APPLICANT: Texas Utilities Electric Company (TUEC)
FACILITY: Comanche Peak Steam Electric Station, Units 1 and 2
SUBJECT: SUMMARY OF MEETING TO DISCUSS THE APPLICANT'S PLAN FOR
RESOLUTION OF REQUESTS FOR ADDITIONAL INFORMATION FROM THE
COMANCHE PEAK TECHNICAL REVIEW TEAM (TRT) EFFORT DESCRIBED
IN LETTER DATED SEPTEMBER 18, 1984.

PURPOSE: To discuss the applicant's program plan for resolution of
open items from the Comanche Peak Technical Review Team
effort described in a September 18, 1984 letter relating
to (1) test program, and (2) civil/structural areas.

ITEM II.D

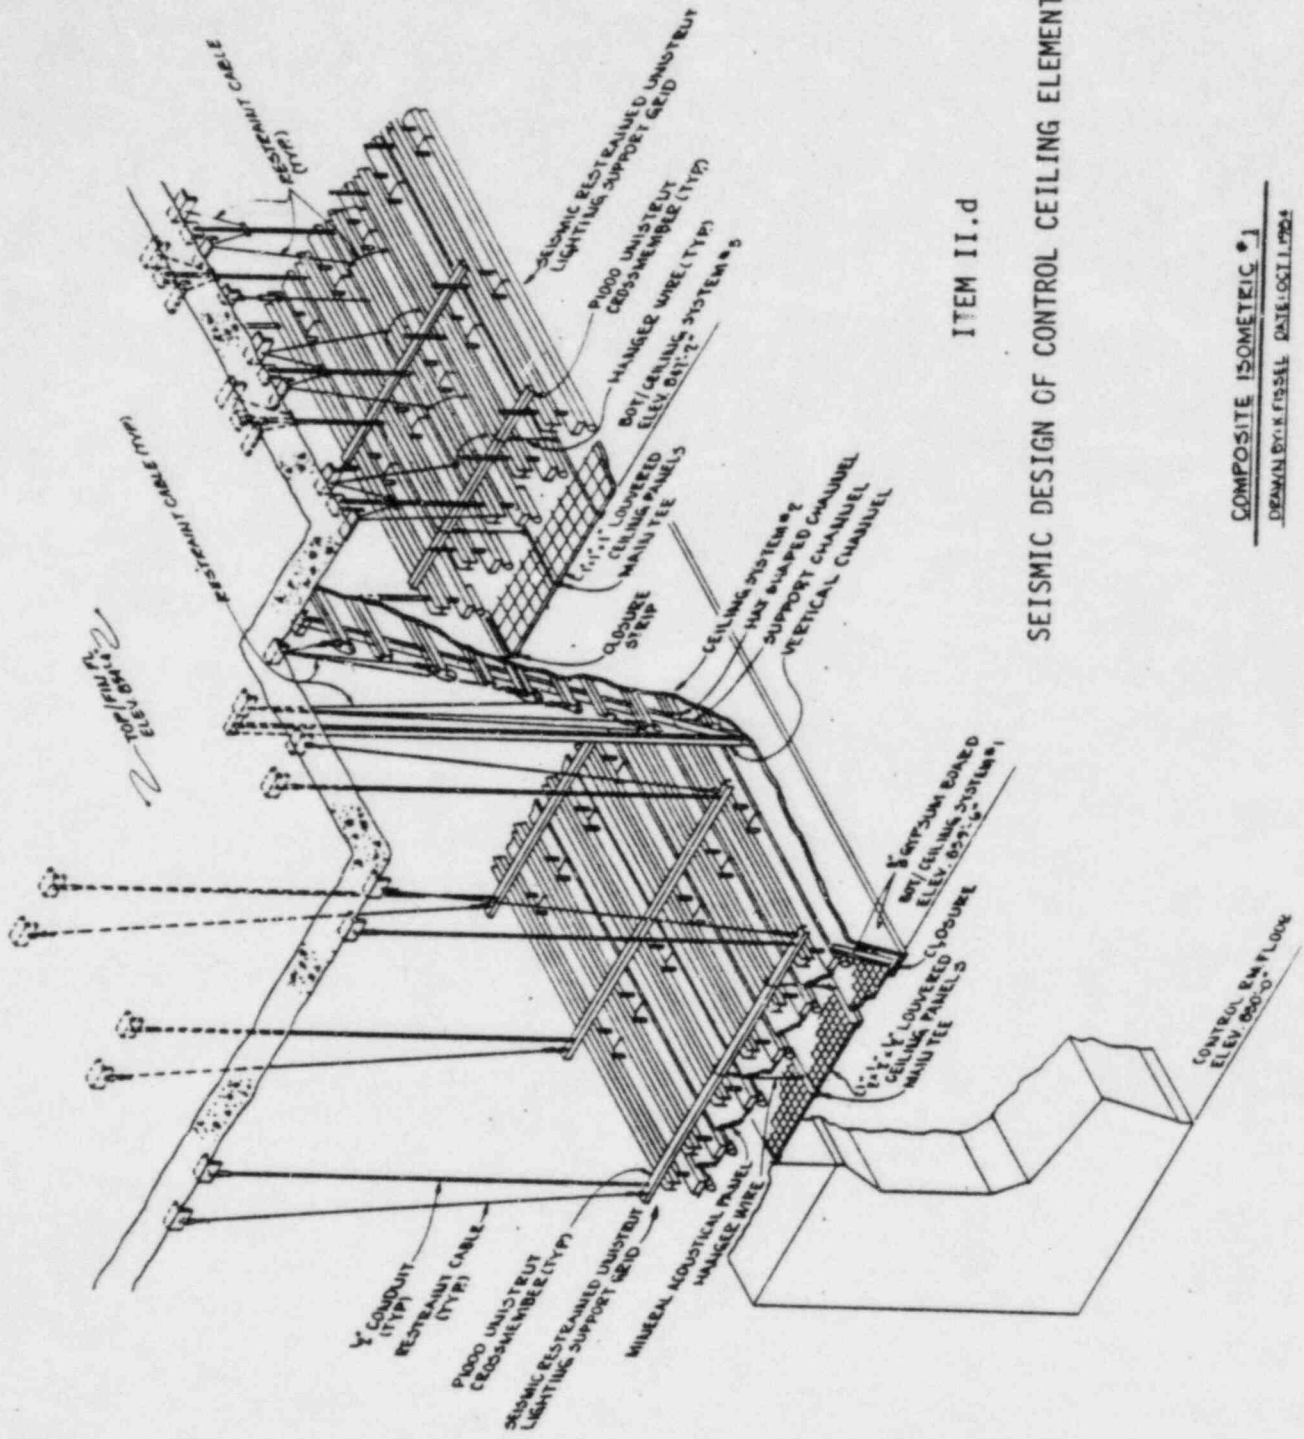
8 This drawing here is a isometric of the control
9 room ceiling. This is the control board and this goes in a
10 horseshoe configuration this way in here to the center. This
11 control room ceiling is really based, comprised of three cei-
12 lings, suspended ceilings.

19 MR. SHAO: It's this kind of judgement I would look
20 at, worry about, maybe you have judgment, so forth in the
21 plane, we think our judgement maybe we don't agree.

16 MR. SHAO; Okay, my general comment is, I think you
17 proved it on the control room itself very good. Okay. But I
18 think you prove it in other parts of the plant, I think it's
19 a big vague. I don't know what you're doing here. If I were
20 to approach it, I would approach it a different way. And I
21 would do a little bit independent audit, outside consultant
22 to look at it, measure your judgement, yes, it was right.

11 MR. JENG: Okay, and the second comment, I think
12 Larry mentioned but I'd like to make sure you keep the
13 comments clear. As to why are you only concerned in the
14 architectural features in your investigation. Whereas there
15 may be architectural features, however, they are still non-
16 seismic items.

16 The other major comment that we had was we're not
17 happy with your naciful category 2 structures different com-
18 ponents. Because you do alot of equivalent status level, you
19 didn't take up conduit interacting because of the two masses.

24 MR. JENG: You do some equivalent status in the
25 control room. We have problem with this. Our question is,

11 Category 1 you did a dynam analysis, category 2 you
12 used a chromostatic analysis. My question is before you made
13 the statement that everywhere else was okay, you look into
14 the category 2 analysis and they ...

4 MR. SHAO: So, we have a lot of trouble with that
5 analysis. So my question is, you say this very unique
6 control room, it doesn't happen somewhere else. Can you give
7 me some proof to back up your statement with?

12 Now, what we would do on this, is we're gonna
13 provide you a seismic analysis, which demonstrates compliance
14 with Reg Guide 1.29, SAR section 37B28. We're going to have
15 to go in and add horizontal seismic restraints. We're going
16 to install those to prevent interaction between the ceiling
17 systems. The concern about the ceilings moving in at each
18 other, we're presently designing some horizontal restraints
19 to stop that interaction so we cannot move the two ceilings
20 together.

1 ceiling will be replaced to expedite resolution in lieu of
2 verification testing. The dry wall ceiling that we have, the
3 question is we've got the structural members seismically sup-
4 ported by air craft cables. We've put the dry wall in, we've
5 put a special configuration of screws in that carry about 60
6 pounds pull out strength, to convince that the dry wall would
7 not separate from structural members.

8 Well, we were getting the questions, well, if it
9 separates, will it come down in little pieces, big pieces,
10 what would it do. Well, we decided that the best thing for
11 us to do is to take the dry wall ceiling out and come up with
12 a ceiling of inverted side, a cork type ceiling where there's
13 no question. Where the composition of the ceiling is not
14 subject like dry wall.

7 The next issue, we're gonna perform an evaluation
 8 on each individual components of acoustical and louvered
 9 ceilings and provide positive attachment if failure is a
 10 concern. All we're saying there is all these T-bars and
 11 these louvered sections, we'll probably air craft cable every
 12 one of them back up to the lighting grid and then probably
 13 loop in every one of these panels to T-bars. So if the thing
 14 shakes and falls, nothing can hit the floor, it's all tied
 15 together. And, that's not a very big effort for us.

4 I guess, Larry, the best way to close this is me to
5 go ahead and include in our plan a action for us to go back
6 and re-review some category 2 designs. And if we see any
7 significant difference between category 1 designs, then be
8 able to explain it.
